SUBMITTAL SUMMARY REPORT MajorSite-000232-2026

PLAN NAME:	Bellevue Substation	LOCATION:	
APPLICATION DATE:	01/09/2026	PARCEL:	4217-223-000
DESCRIPTION:	Application for Major Site Plan of a proposed electrical substation.

Type of Application MAJOR SITE PLAN
BELLEVUE SUBSTATION 2026 NEW RING BUS STATION CIVIL INFORMATION NOTES

KARST REPAIR DETAIL

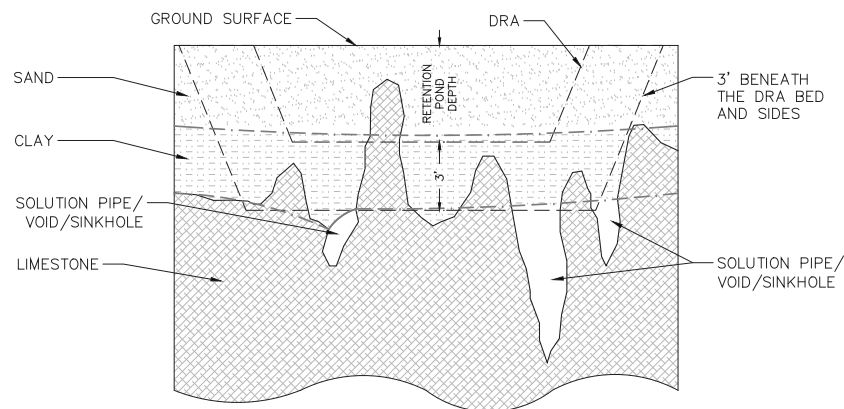
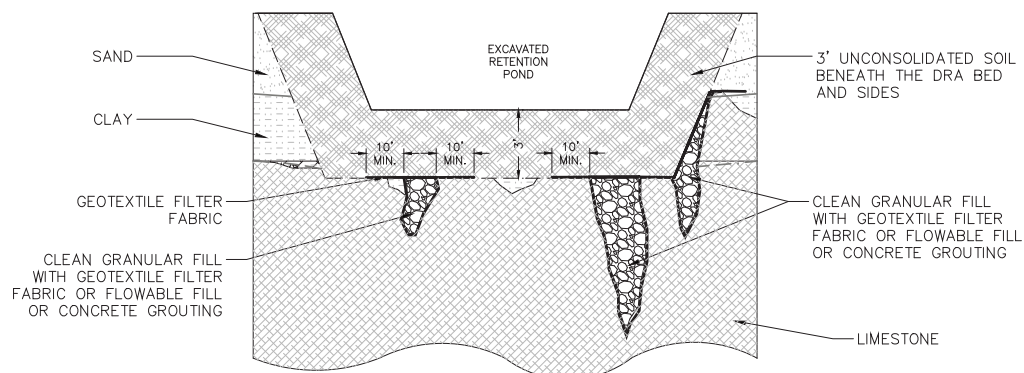
ITEM REVIEW NAME (DEPARTMENT)	ASSIGNED TO	DUE	COMPLETE	STATUS
OCE Stormwater (Permits & Plans) (Office of the County Engineer)	Alexander Turnipseed	01/27/2026	01/13/2026	Requires Re-submit
<i>Corrections</i>	6.10 - Karst Topography and High Recharge Areas (Not Resolved) - Corrective Action: Please provide a signed and sealed karst analysis - 6.10 - Karst Topography and High Recharge Areas: An application for any new development or expansion of existing development, located within a high recharge or karst sensitive area as designated by the appropriate water management district or Marion County maps, shall submit an analysis of site conditions in sufficient detail to define hydrologic and geologic conditions which may guide mining, land development, or construction activities on the proposed site. Karst analysis shall include depiction of karst features on the project site and off-site within 200 feet of the project boundary. Karst analysis should be signed and sealed by an engineer.

Revision:	BY:	Date:
KARST REPAIR DETAIL ADDED TO THE PACKAGE PER MC COMMENTS		
	BHT	5/28/26
